**TOWN OF LOS GATOS  
COUNCIL AGENDA REPORT**

DATE: November 10, 2022  
TO: Mayor and Town Council  
FROM: Laurel Prevetti, Town Manager  
SUBJECT: Consider Adoption of a Resolution Establishing Objective Standards for Qualifying Multi-Family and Residential Mixed-Use Developments.  
Location: Town-wide. Applicant: Town of Los Gatos.

Figure A.3.1

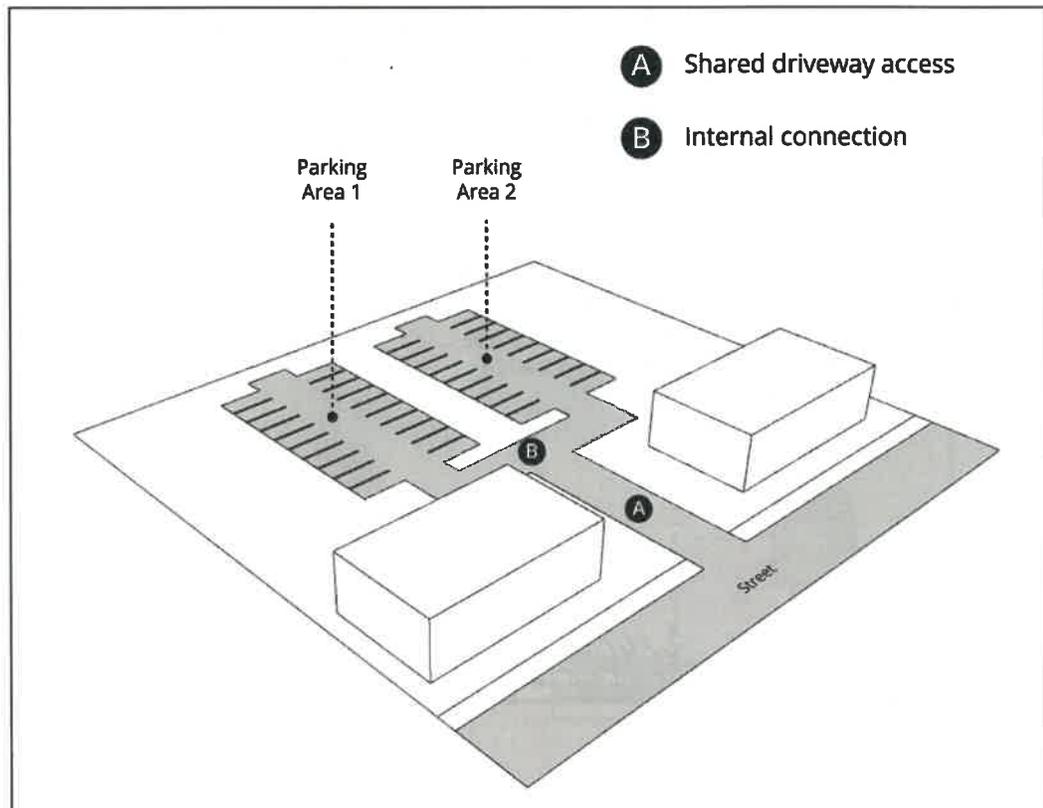
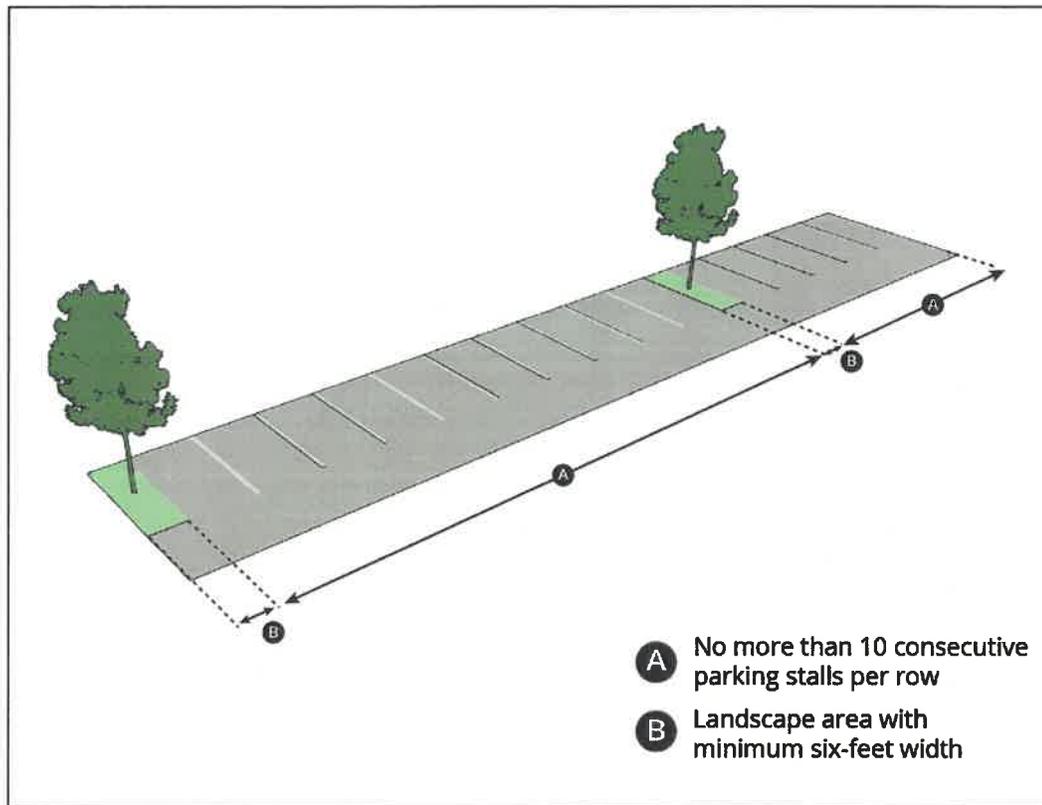
**A.3 – Vehicular Access.** Comments were received from the public questioning the difference between the vehicular access standards in A.3.1 and A.4.2. The intent of the two standards is the same: to require parking lots to be internally connected: and prohibiting use of a public street to access two different parking areas. Standard A.3.1 was amended to incorporate A.4.2, and A.4.2 was deleted.

- 3.1 Off-street parking lots shall have ~~vehicular circulation using an~~ internal vehicular ~~circulation network~~ that ~~precludes~~ preclude the use of a ~~public~~ street for aisle-to-aisle ~~internal~~ circulation.

**Figure A.11.1**

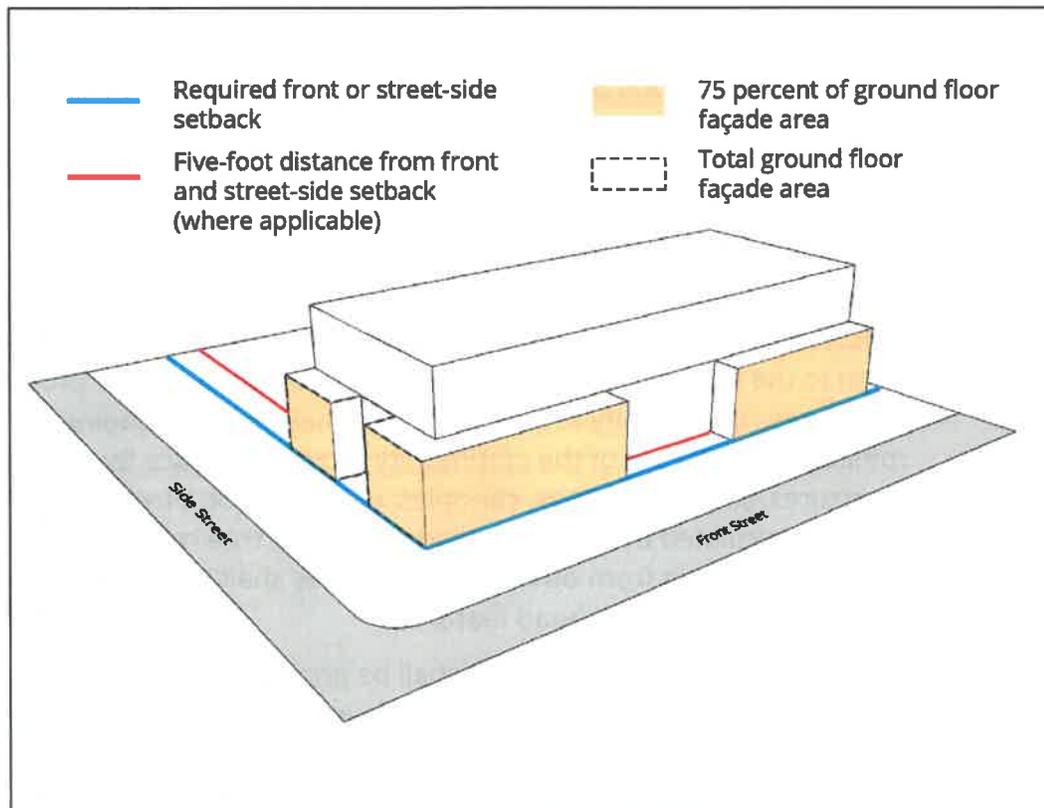
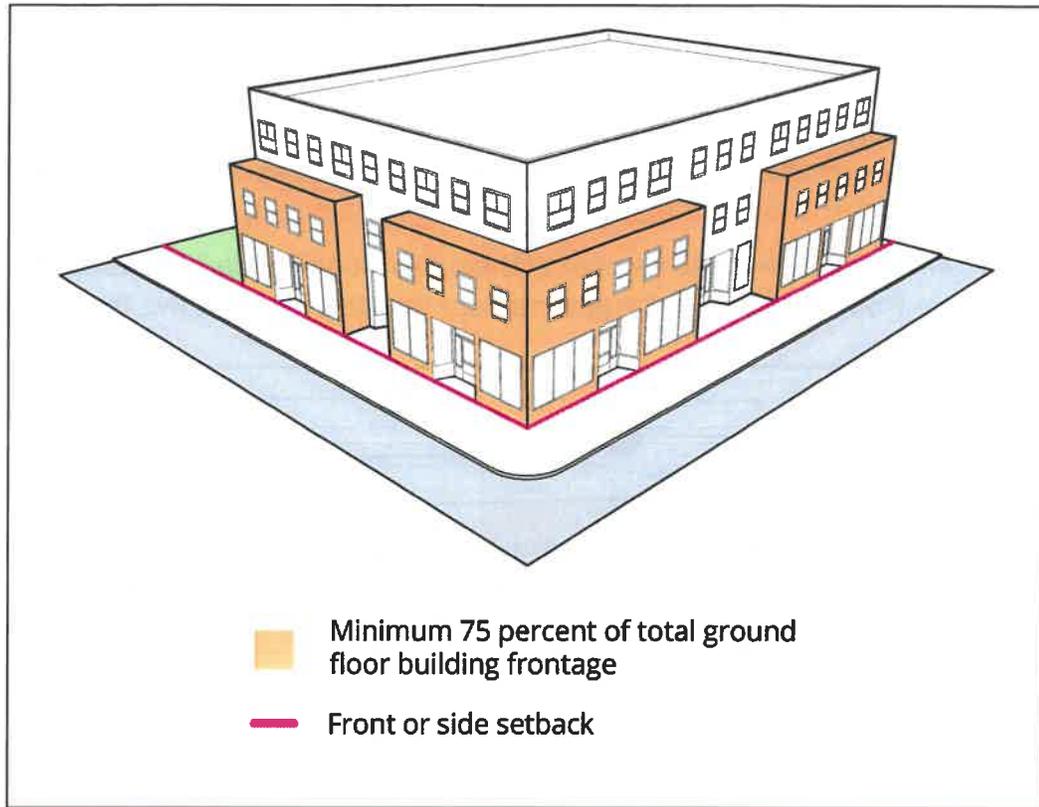
**A.11 – Building Placement.** Public comment was received questioning if the setback standard in A.11.1 applies to the entire site or just building footprints, and a request that the maximum percentage of ground-floor site amenities be removed in A.11.2. Planning Commission supported these requests, and the Draft Objective Standards document was amended as follows:

- Amendment of Draft Objective Standard A.11.1 to clarify that the 75 percent continuous frontage requirement applies to the amount of the ground floor street-facing façade;
- Replacement of the term “Community Growth District” with “commercial zones” based on the current status of the General Plan Land Use Element; and
- Amendment of Draft Objective Standard A.11.2 to remove the maximum percentage that site amenities can occupy within the area between the building and the street.

Figure A.3.1

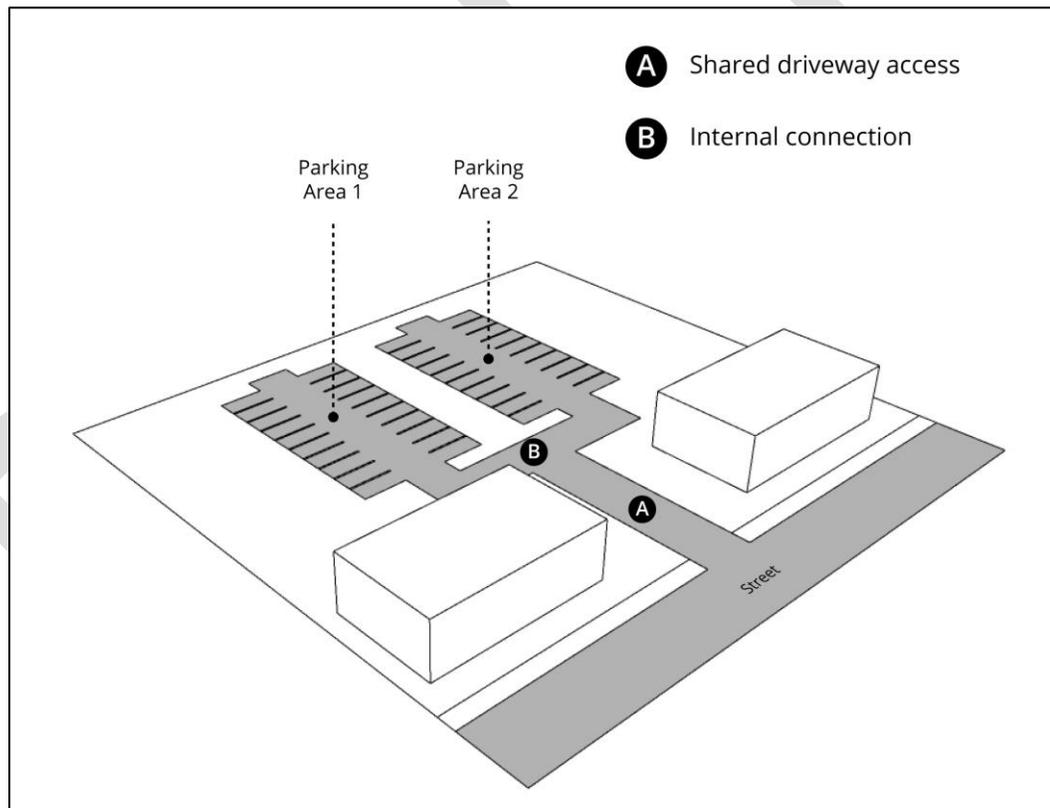
Figure A.3.1, A.3.1 and A4.3 need clarification

:What is the difference between aisle to aisle circulation (A3.1) and parking areas (Figure A3.1)? Does Figure A.3.1 represent multiple parking areas (see A.4.2) or aisle-to-aisle circulation of A.3.1.

**Figure A.11.1**

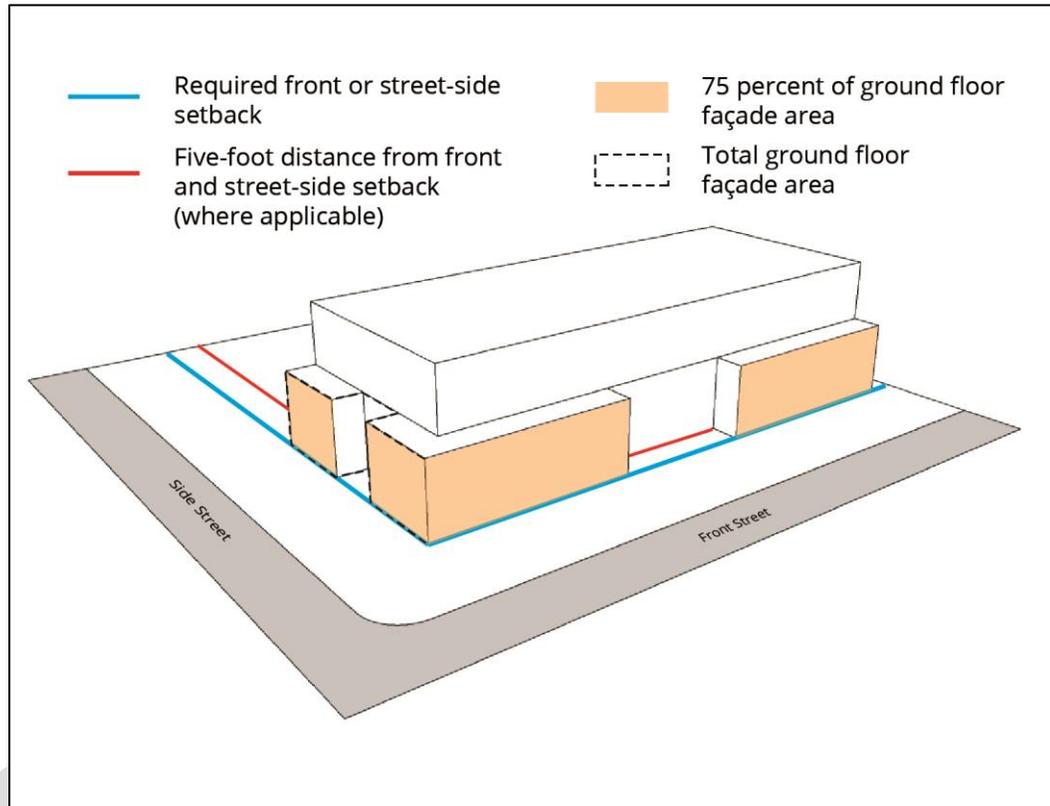
41	A.10.1	A.11.1	Why does this only include Community Growth Districts (CGDs)?	<p>The following polices discussing setbacks are included in the Community Design Element of the 2040 General Plan:</p> <p><b>CD-2.10 (Town-wide): Well-Defined Street Fronts</b> - Require new buildings to maintain a consistent setback from the public right-of-way in order to create a well-defined streetscape. Require new buildings throughout Town to use consistent setbacks.</p> <p><b>CD-7.1 (All CGDs): Neighborhood-Friendly Design</b> - Encourage buildings and sites within all Community Growth Districts regardless of designation, including shopping centers undergoing redevelopment, to integrate design features that create a pedestrian- and neighborhood-friendly environment, such as by siting buildings close to the sidewalks, providing space for small plazas, and including public art.</p> <p><b>CD-9.1: (LGB CGD): Setbacks and Step Backs of Massing</b> - Require medium density, high density, and mixed-use parcels in the Los Gatos Boulevard District adjacent to single-family parcels to include increased site setbacks and multi-story step backs to minimize the impact and increase compatibility with smaller adjacent structures.</p> <p><b>CDP-11.7: (Lark CGD): Reduced Setbacks</b> - Allow reduced setbacks to foster a more urban environment focused on corporate centers, commercial shopping areas, medical services, and hospitality uses.</p> <p>Consistent setbacks are encouraged by CD-2.10, while reduced setbacks are encouraged in CGDs. For this reason, Standard A.11.1 was written specific to CGDs. <b>Given the above polices and the comments made by the Commission during discussion of this item, staff requests direction on whether this standard should apply Town-wide or only within CGDs.</b> The corresponding figure/diagram will be updated accordingly.</p>
